RE: Mamre Road Precinct – Request for Additional Information – Traffic Modelling

P1815 – Mamre Road Precinct – LOG East – Revised 2026 Modelling

To	Landowners Group – East	info@asongroup.com.au +61 2 9083 6601
FROM	Andrew Johnson (Director); Ason Group	Suite 17.02, Level 17, 1 Castlereagh Street, Sydney, NSW 2000
CC		ABN: 81 168 423 872
SUBJECT	Mamre Road Precinct – Revised Modelling and Warrants Assessment

Figure 1 Road Network Hierarchy

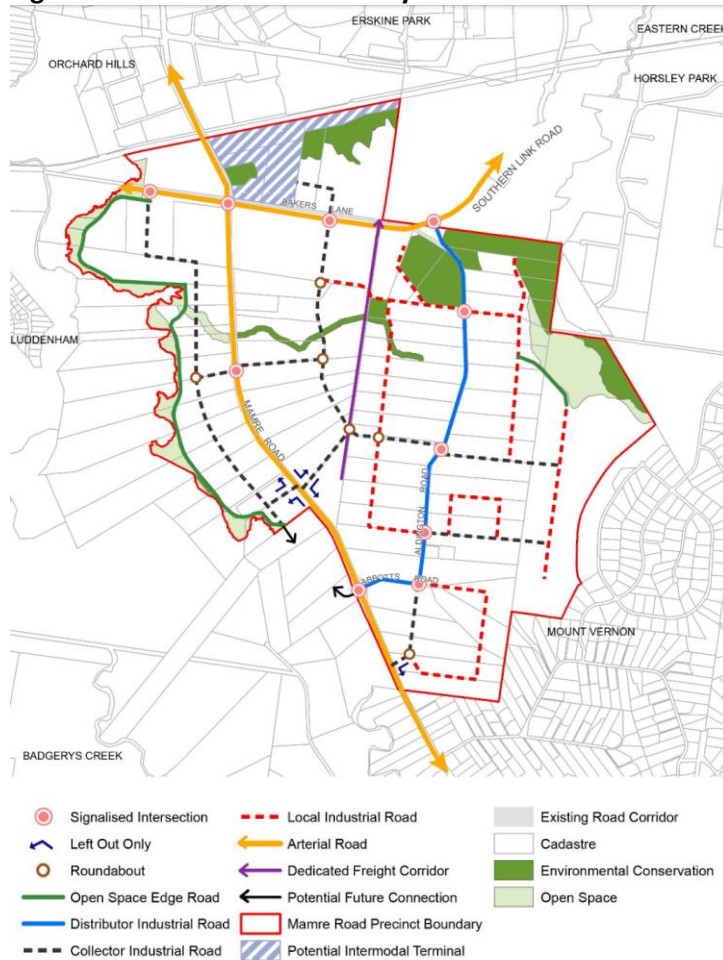
The Intersection Warrant Analysis along Aldington Road: Modelling should take into account options for roundabouts and signals. If the warrants are not met (and signals cannot be supported within the medium and long term) there must be adequate land dedicated for the roundabouts in the interim.

The identification of signalised intersections for this important corridor as it was determined through extensive modelling and consultation, which was used to inform the Mamre Road Precinct Development Control Plan (DCP) (refer to **Figure 1** below).

As stated earlier, the installation of signals may occur outside the guideline due to public pressure or an administrative directive. In the case of Abbots and Aldington Roads intersections, the precinct-

wide DCP should be recognised as an administrative direction as it identifies where signalised intersections are to be located. Further, Penrith City Council has stated their preference in signals due to their desire for the ultimate solution delivery under the planning agreement.

Based on the above information, we believe there is sufficient justification and support to approve signals given it is consistent with the medium-long term.

Figure 1: Road network Extents and LOG Ownership

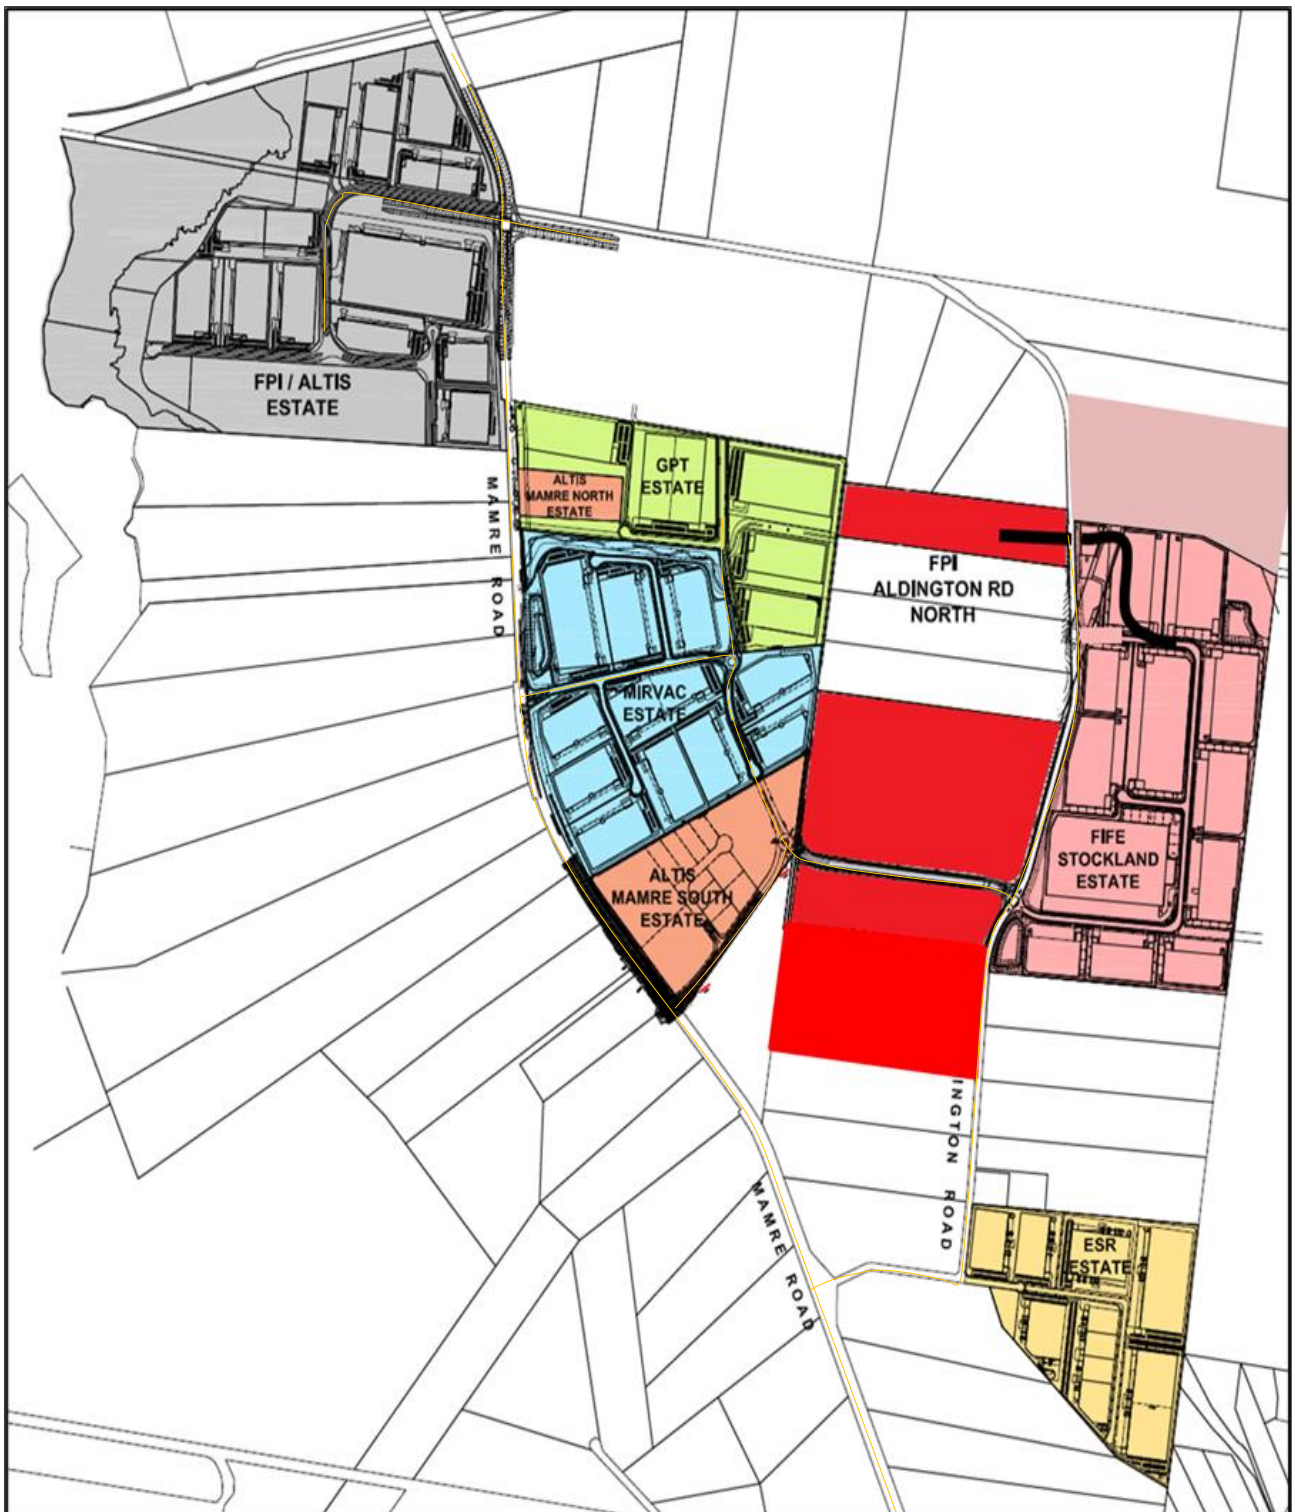
- a. Road Network to be modelled (Figure 1): Option testing should be provided to understand the threshold that the intersection will operate at an unacceptable Level of Service***

Scenario modelling was undertaken within the Southern Link Road in year 2026. The modelling shows how the Landowner's Group can unlock GFA in the short-medium term. A breakdown of this analysis is contained in the Ason memo attached.

Figure 12: Additional Upgrades under 75% GFA Scenario

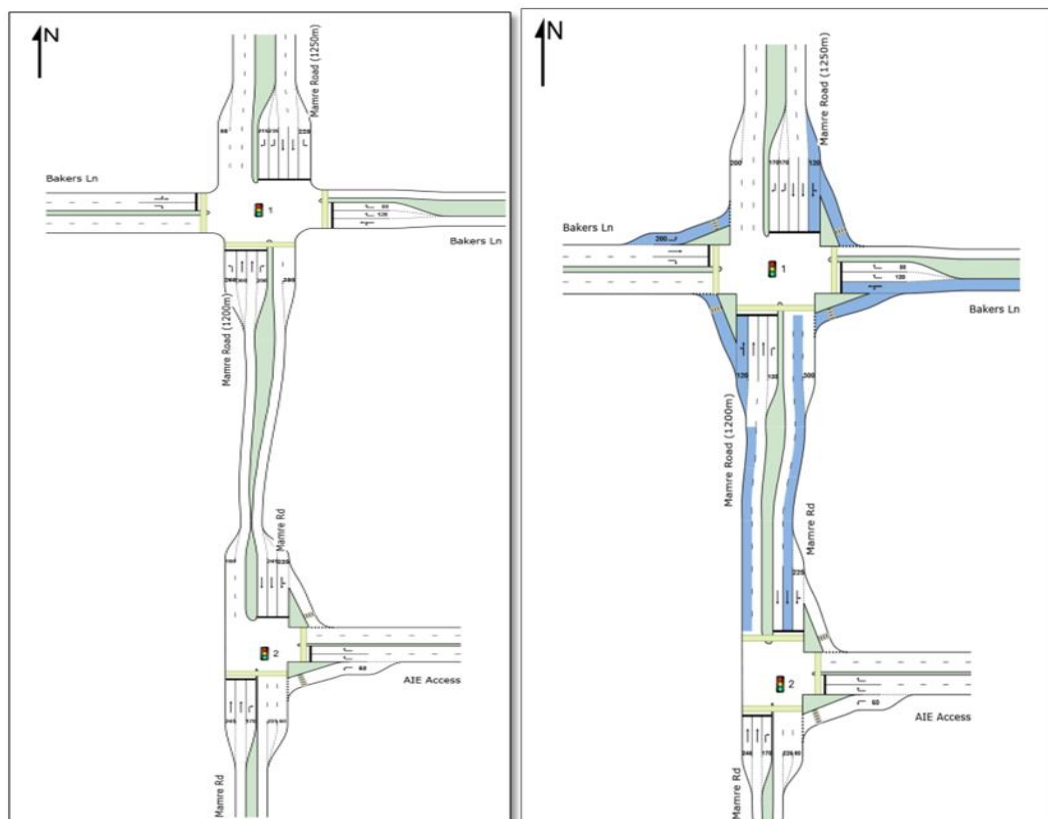
- Option testing should be provided to understand the intersection thresholds.
- The 75% LOG GFA assumptions to be modelled under the revised scenario and adjusted, if required.
- Mamre Road (south of Erskine Park Road) lane assumptions are to be consistent with the existing (and approved) lane arrangements
- An intersection warrant analysis is to be included for the key intersections along Aldington Road

Figure 12 below shows the assumed Mamre Road and Aldington Road corridor, the required upgrades are listed below and highlighted blue in the figure.

- Generally improved network operation with reduced queues and delays at Bakers Lane with Mamre Road
- All intersections and individual legs operate with delays and degree of saturation within the limits set by TfNSW
- Spare capacity at all intersections to enable further development above the 1,291,584m² modelled.

The additional upgrades identified can therefore accommodate at least the 1,291,584m² GFA of the relevant Land Owners Group. Additional capacity would also be available for smaller applications within the precinct that would unlikely result in any further degradation below the acceptable thresholds nominated by TfNSW.

Figure 13: Additional Road Network Upgrades

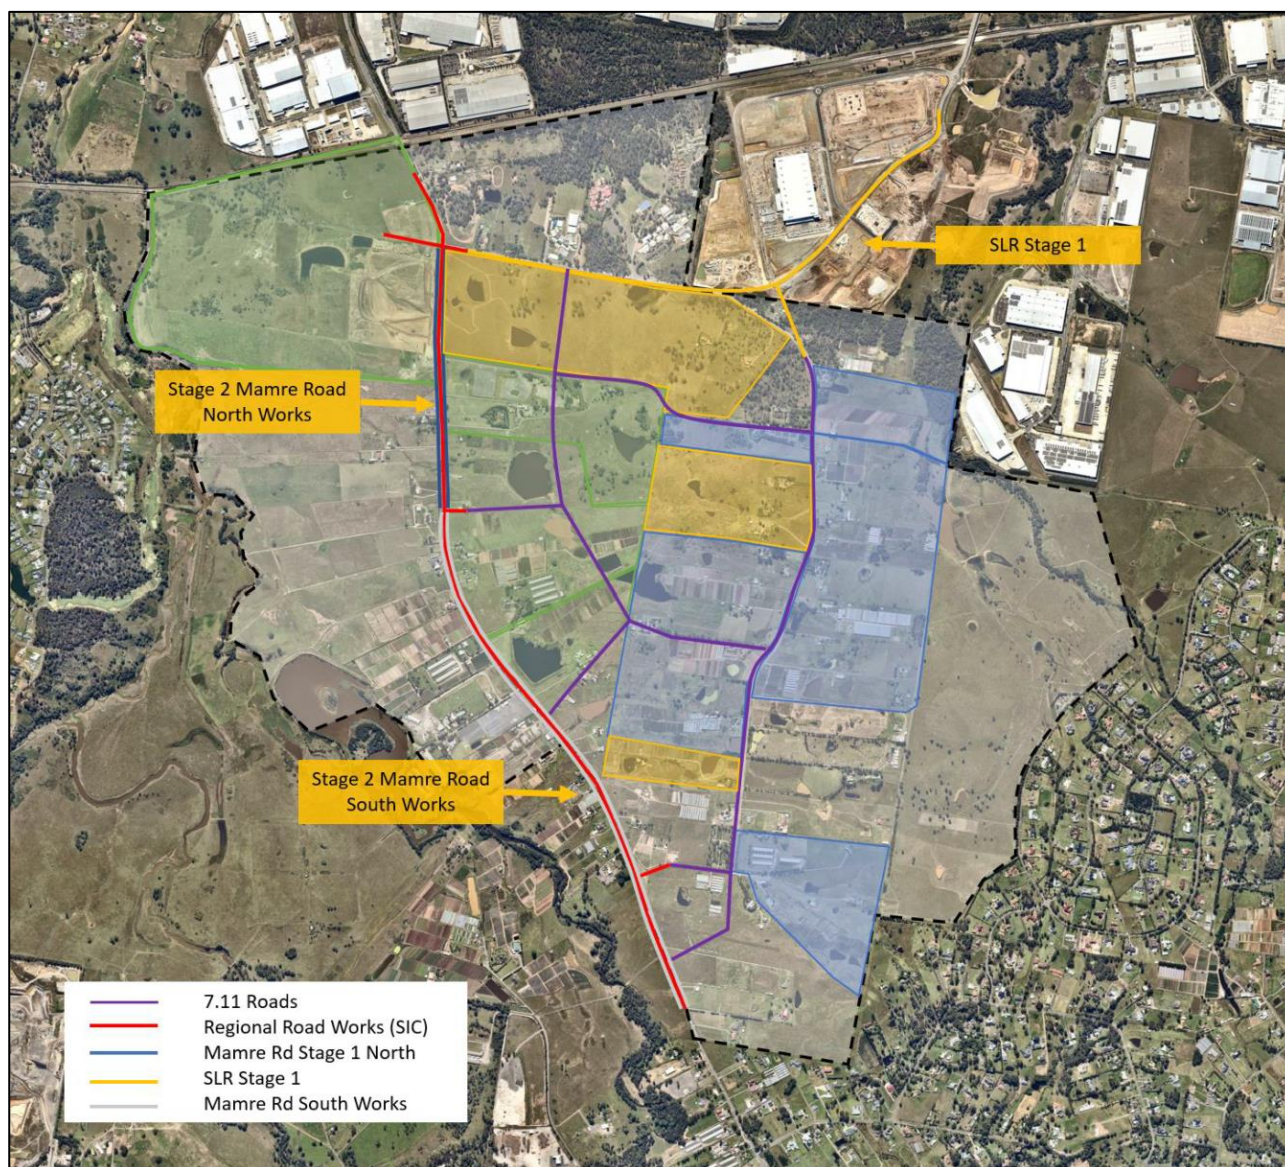
The main constraint within the network is the lack of north-south capacity. The logical next stage of works is the delivery of the SLR Stage 1, which would provide a connection between Mamre Road and Compass Drive (including a new connection with Aldington Road). This connection would provide direct access to Lenore Drive, reducing the reliance on Erskine Park Road and Mamre Road and providing an alternate route to the M7 and M4 motorways.

Additional localised capacity can also be achieved through the further widening of Mamre Road, between Mirvac Site Access to Kerrs Road (see Figure 13). This widening would provide additional north-south capacity.
